P & ID  
RESIDUAL HEAT REMOVAL  
(RH)  
R. H. ZIMMER NUCLEAR POWER STATION UNIT I  
THE CINCINNATI GAS & ELECTRIC CO.  
COLUMBUS & SOUTHERN OHIO ELECTRIC CO.  
THE DAYTON POWER & LIGHT CO.

SARGENT & LUNDY  
CHICAGO  
DRAWING NO. M-51  
SHEET 2 OF 4

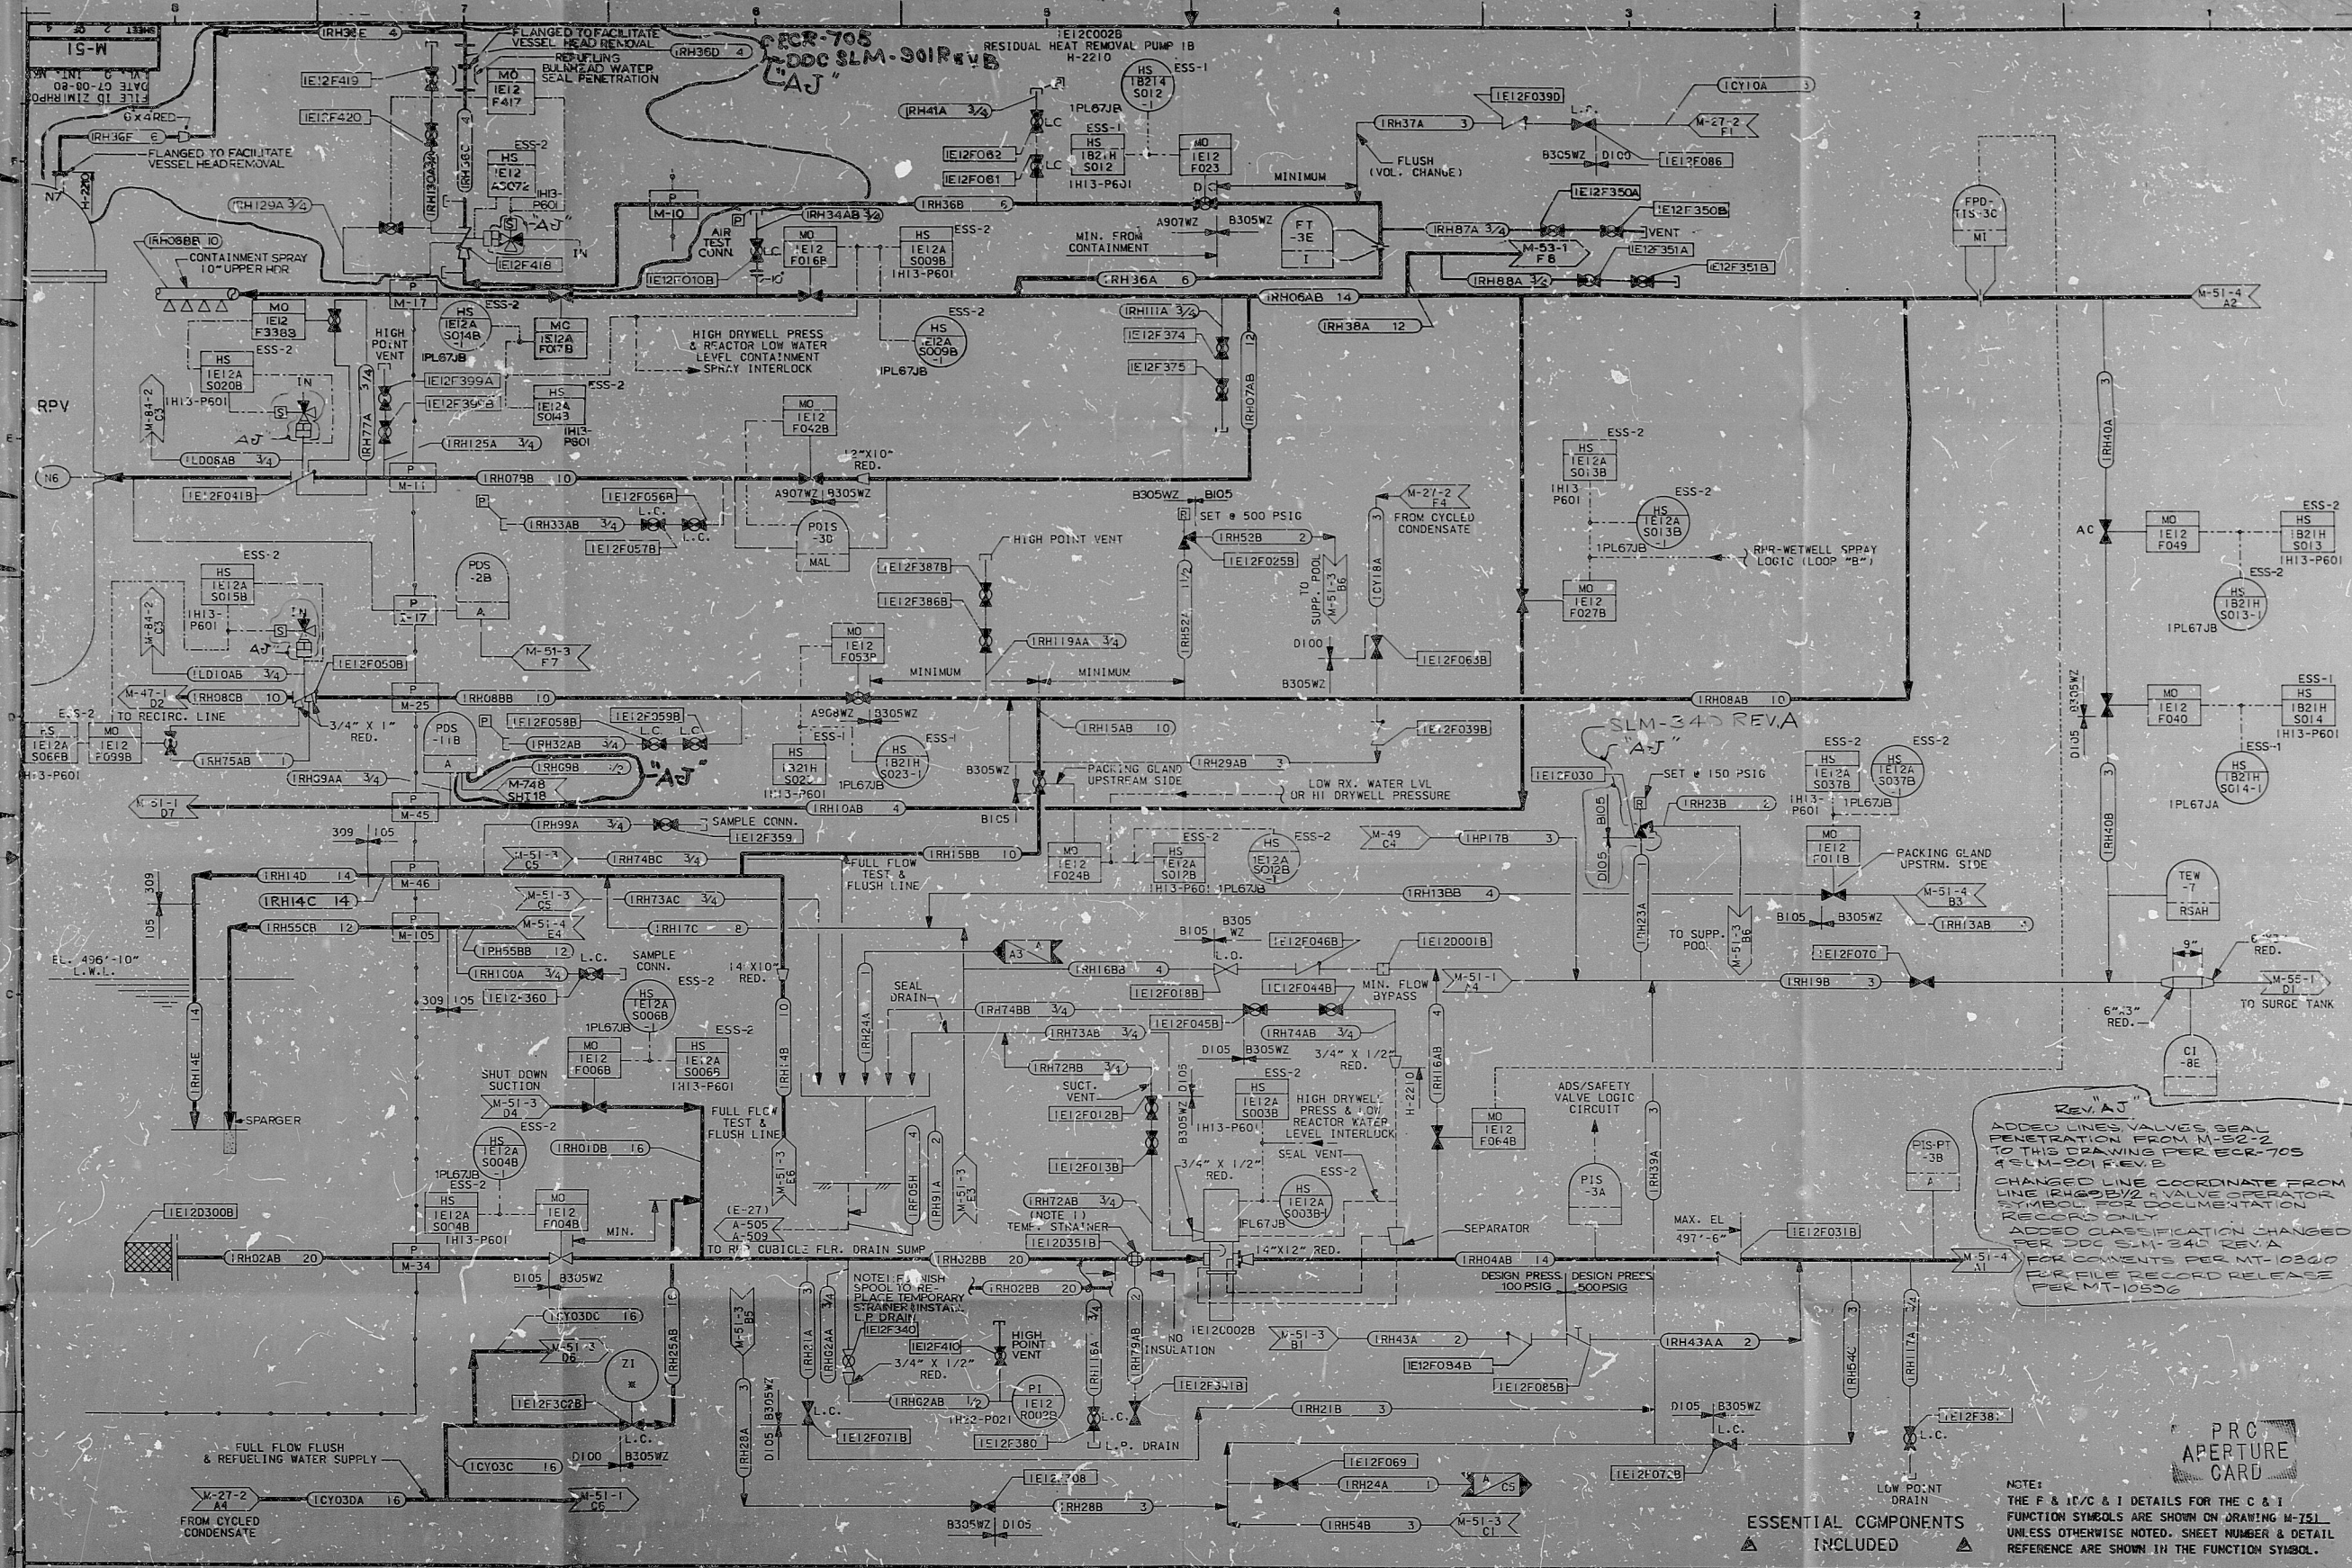
REV. A  
ADDED LINES VALVE SEAL  
PENETRATION FROM M-51-2  
TO THIS DRAWING PER PRC-705  
SLM-340 REV. A  
CHANGED LINE COORDINATE FROM  
LINE 1000000 TO VALVE OPERATOR  
SYMBOL FOR DOCUMENTATION  
RECORDS ONLY  
ADDED CLASSIFICATION CHANGED  
PER PRC-705 SLM-340 REV. A  
FOR COMMENTS PER MT-10300  
FOR FILE RECORD RELEASE  
PER MT-10300
